GS#411-119
PARKING LOT IMPROVEMENTS AT BRADLEY SANDERS BUILDING
EAST MISSISSIPPI STATE HOSPITAL
MERIDIAN, MS

ADDENDUM NO. 1

DATE: October 18, 2017

F.B.	P.	DATE: 8/8/2016	SHEET
DWG FILE: \Civil 3D Projects\Private Projects\2015 \15-133 E MS Sanders\Coord-15-133 Bradley Sanders Building Parking Lot.dwg JOB NO. 15-133 DRAWING NO. D-4399		DRAWN BY: KHM CHECKED BY: KHM SCALE: AS SHOWN	2 OF 6

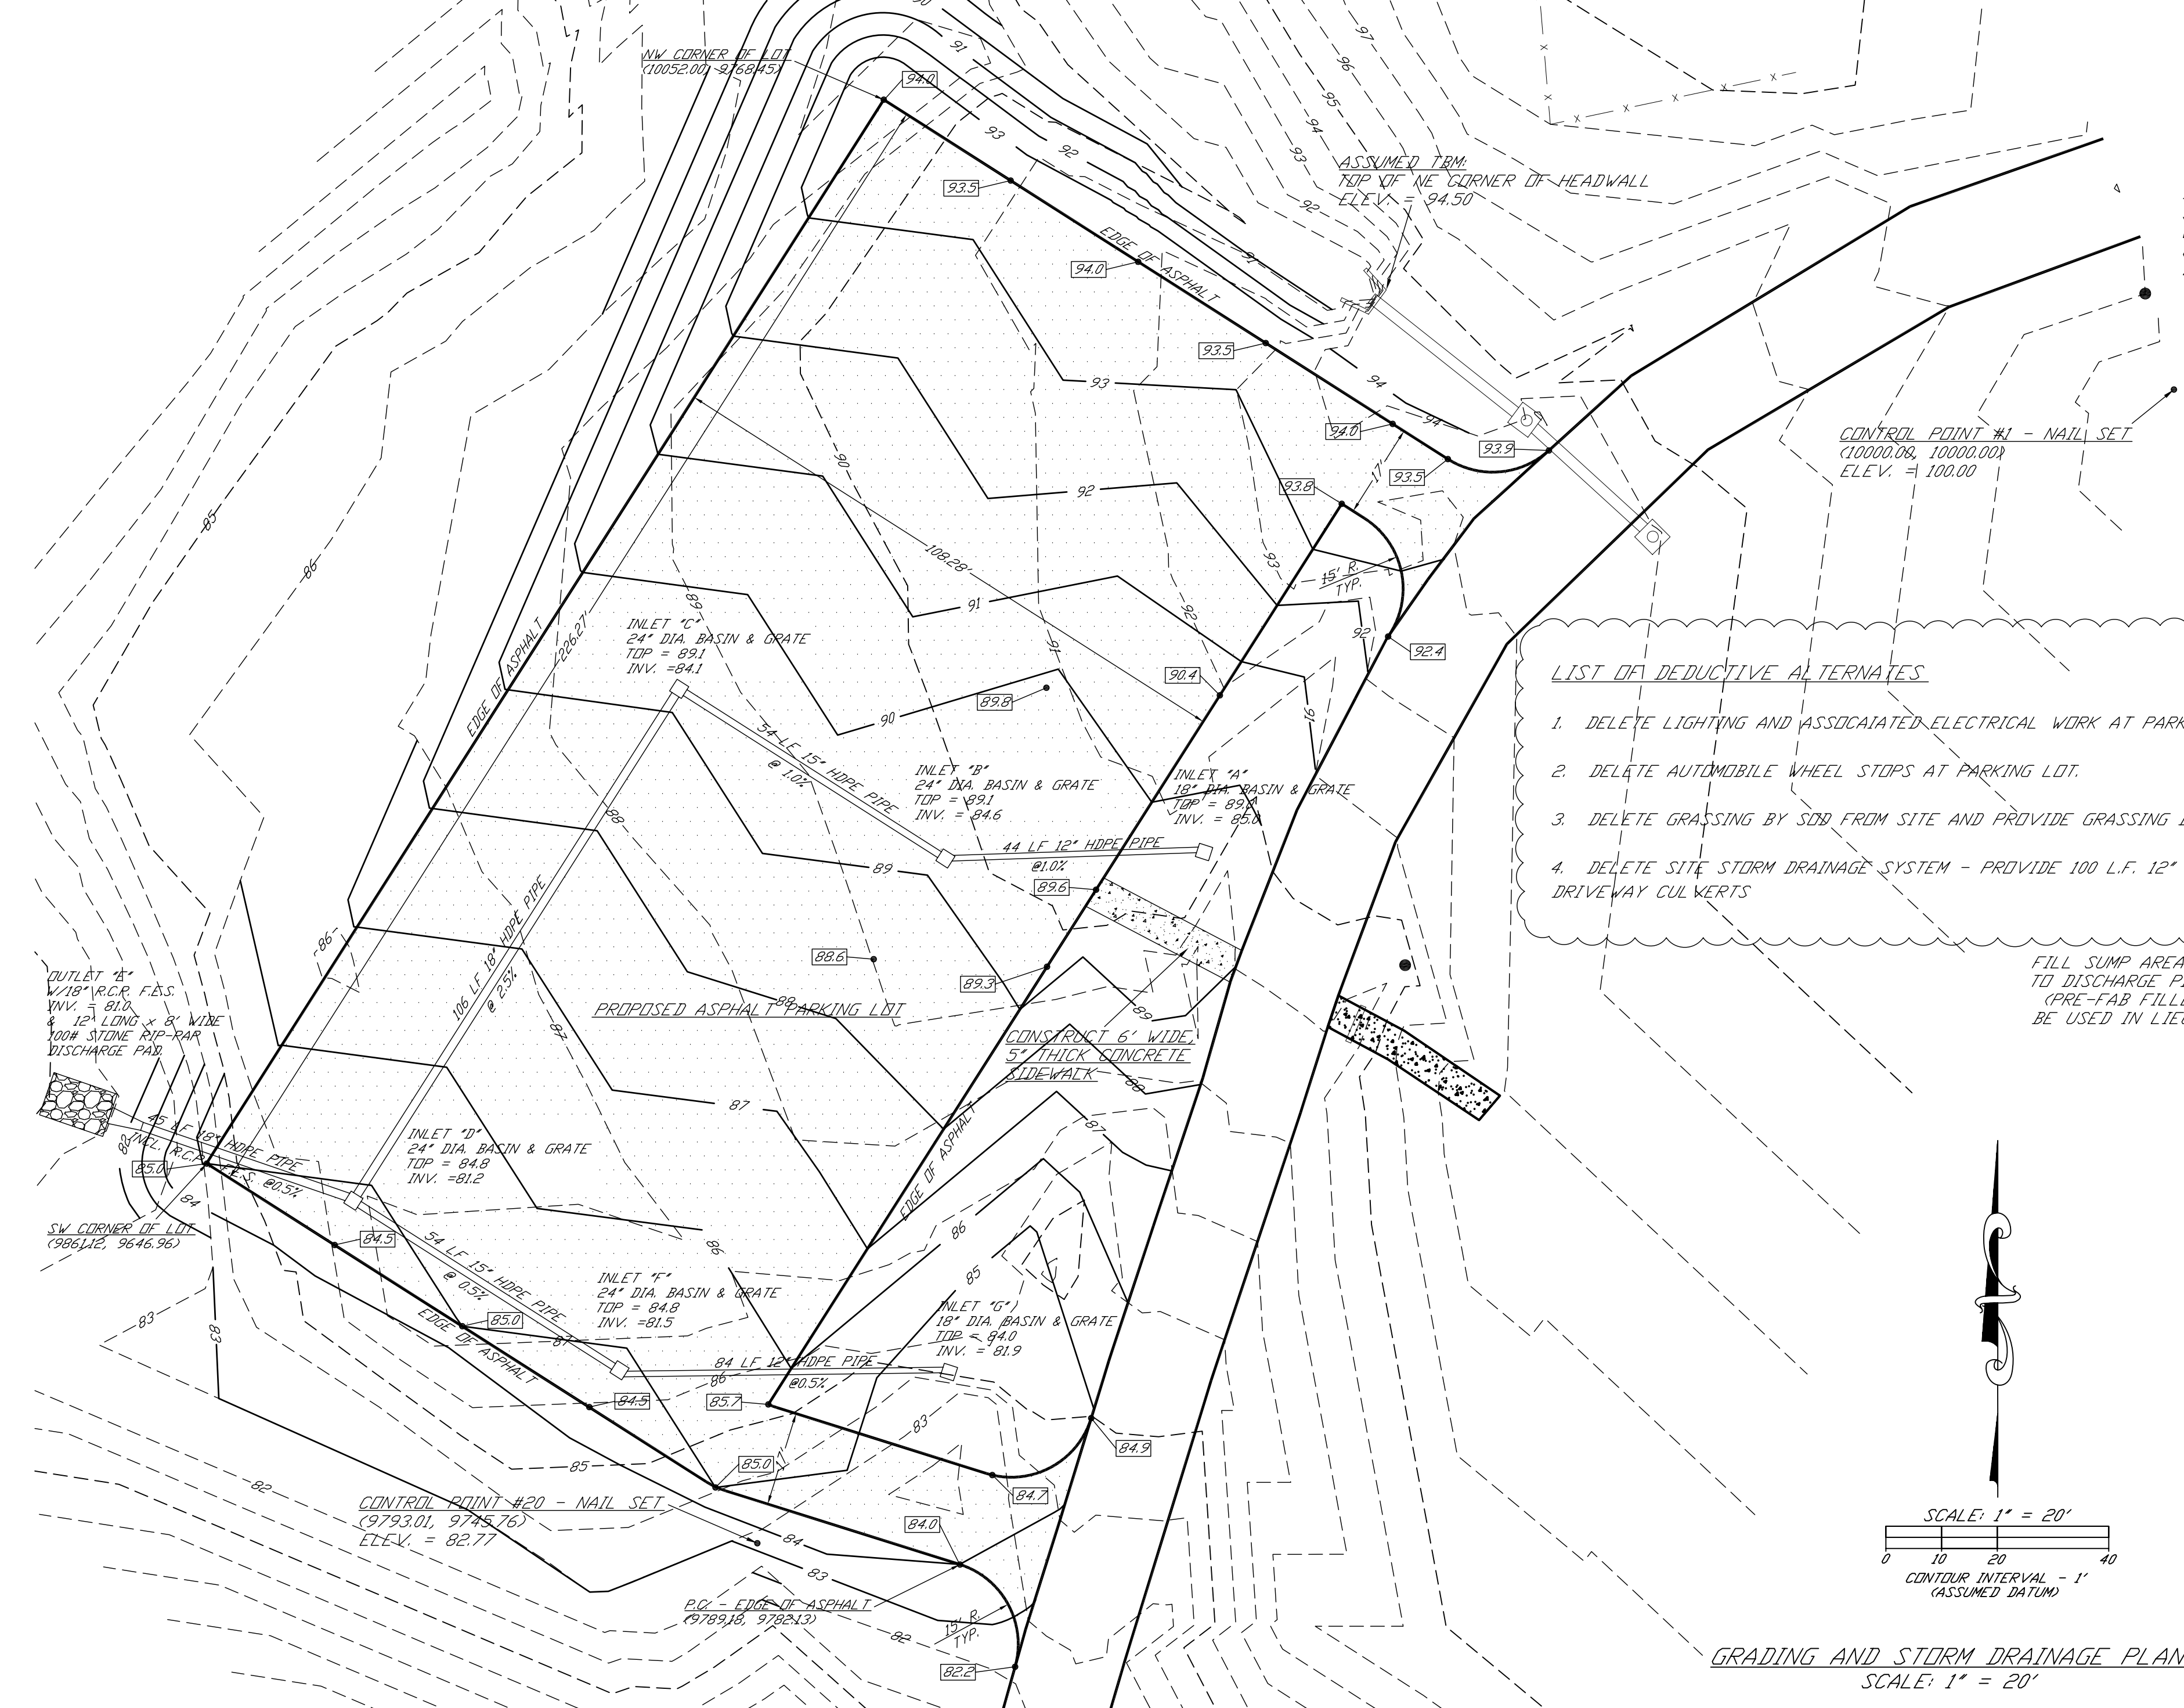
1. **REPLACE:** Sheets 1.0, 2.0, 3.0, 4.0 shall be replaced with the attached sheets. Corrections to contours were made resulting in adjustments to the silt fence and clearing limits.

4. **CLARIFICATION:** All debris shall be properly disposed of off-site. Refer to note 2, sheet 2.0.
5. **COMMENTS from Pre-Bid meeting:**
 - A. Leave no blanks on the Bid Form. If the requested information is not relevant, then mark it as 'NA'. Bid will be rejected if you leave it blank.

2. **CLARIFICTION:** Any area disturbed by construction activity shall receive solid sod as noted on sheet 3 note 10.
3. **CLARIFICATION:** Any excess material is to be hauled off site or may be used on the back slopes. Slopes may be extended if needed to use excess material. All fill material shall be placed and compacted as required by geotechnical report and noted on sheet 3. All requirements remain the same.
